Access Compliance Report

Public Rights-of-Way

(Curb Ramps)

Intersection ID: 28277	Main Street: EASTON_GREY_LN	Cross Street: PEMSWOOD_ST	Location: S
ADA ID: DE611BEC89A4	Ramp Type: Perp	Initial Pass/Fail: Fail	Overall Compliance: No
Severity Score: 12.5			
Codes/Mitigation Info/Possible Solution		Field Measurements/Component Compliance

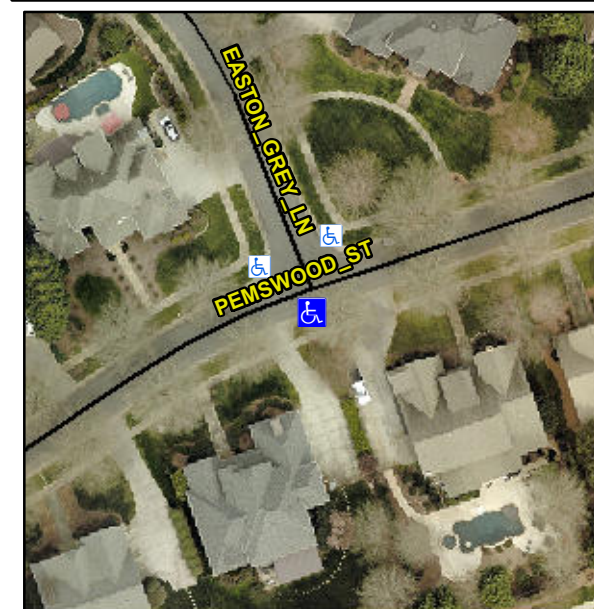
Not Found, R304.2.2

Compliance	Description	Data	Compliance	Description	Data
N/A	Ramp Length (in)	95.0	No	Ramp Slope (%)	9.7
Yes	Ramp Width (in)	59.0	Yes	Ramp XSlope (%)	1.6
N/A	Flare Type LT	N/A	N/A	Flare Type RT	N/A
N/A	Flare Slope LT (%)	N/A	N/A	Flare Slope RT (%)	N/A
N/A	Flare Traversable LT?	N/A	N/A	Flare Traversable RT?	N/A
N/A	Landing Length (in)	N/A	N/A	DWS Provided?	N/A
N/A	Landing Width (in)	N/A	N/A	DWS Contrast?	N/A
N/A	Landing Slope (%)	N/A	N/A	DWS Length (in)	N/A
N/A	Landing X Slope (%)	N/A	N/A	DWS Full Width?	N/A
N/A	Landing Curb? (Y/N)	N/A	N/A	DWS Offset (in)	N/A
N/A	Shared Landing?	N/A			
N/A	Gutter Ponding?	Yes	N/A	Gutter Slope (%)	N/A
N/A	Gutter Lip Ht (in)	N/A	N/A	Gutter X Slope (%)	N/A
N/A	Painted X Walk1?	No	N/A	Painted X Walk2?	N/A
	X Walk 1 Direction	To NW		X Walk 2 Direction	N/A
N/A	X Walk 1 Width (in)	N/A	N/A	X Walk 2 Width (in)	N/A
	X Walk 1 Slope (%)	5.7		X Walk 2 Slope (%)	N/A
	X Walk 1 X Slope (%)	0.4		X Walk 2 X Slope (%)	N/A

Remove & Replace Entire Ramp.
